HISTORIC AND DESIGN REVIEW COMMISSION

November 03, 2021

HDRC CASE NO: 2021-540
ADDRESS: 401 SHOOK AVE
LEGAL DESCRIPTION: NCB 6327 BLK 2 LOT NE TRI 5.3 OF 56 & EIRR 45 OF THE S 100 OF 57 & S 99.58 OF 58
ZONING: R-5
CITY COUNCIL DIST.: 1
DISTRICT: Monte Vista Historic District
APPLICANT: Lewis McNeel/MCNEEL LEWIS MAVERICK
OWNER: Lewis McNeel/MCNEEL LEWIS MAVERICK
TYPE OF WORK: Window and door replacement
APPLICATION RECEIVED: October 02, 2021
60-DAY REVIEW: Not applicable due to City Council Emergency Orders
CASE MANAGER: Katie Totman

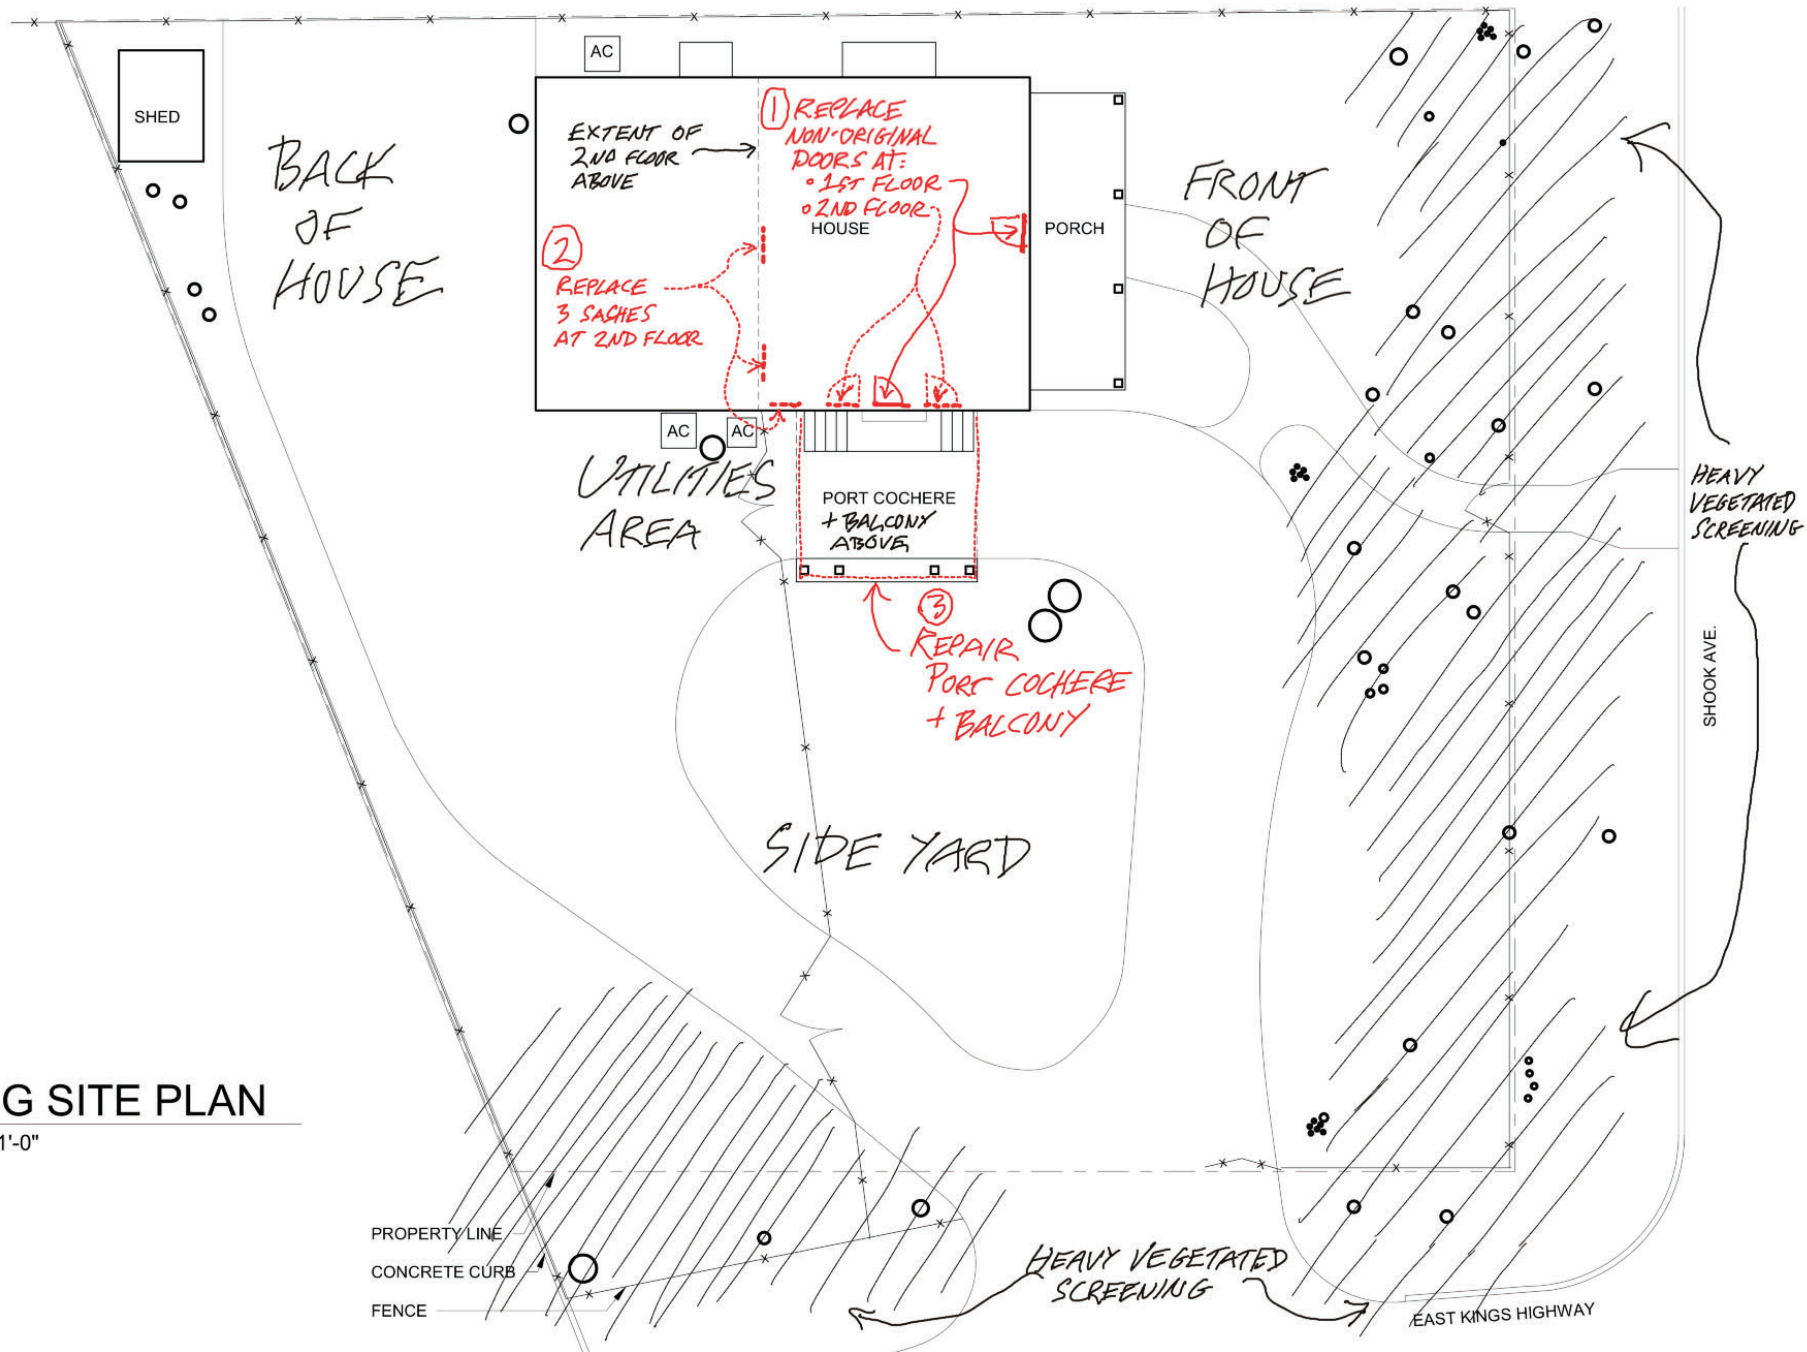
REPLACE
DOORS

TYPICAL
NON-ORIGINAL
DETAILS POORLY
CONCEIVED & EXECUTED

REPLACE
WINDOWS

REPLACE
DOORS

Staff recommends approval of item 2 based on finding f with the stipulation that the front door be retained and the proposed replacement doors above and beneath the porte-cochere be wood and feature a paneled appearance to be in line with the existing appearance; a final door specification and design will need to be provided to staff prior to the issuance of a COA.

Staff does not recommend approval of item 1 based on findings b through e. The Historic Design Guidelines always recommend that the repair of historic-age windows be prioritized over replacement. Individual sashes that are severely deteriorated or damaged may be replaced with in kind wood sashes of traditional construction methods.
